### Product Change Notification

Type of Notification: Changing a Physical Appearance of Chassis

PBA10F-□, PBA15F-□, PBA30F-□, PBW15F-□, PBW30F-□, PMA15F-□

Table 2.2 Comparison between Before and After Changes [Example: PBA10F]

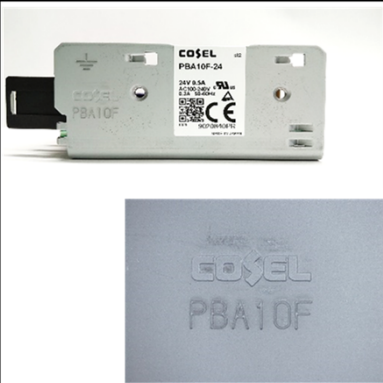
The plating specifications of the chassis regarding the above products will be changed as shown in Table 2.1 due to reliability improvement. The color of shade becomes change. but this change does not impact the electrical specification, the external dimensions and mounting dimensions.

No.	Changed contents	Before	After
1	Chassis material	Electric galvanizing steel board	Hot-dip galvanized steel plate

\* The color shade will change because of the plating process change.
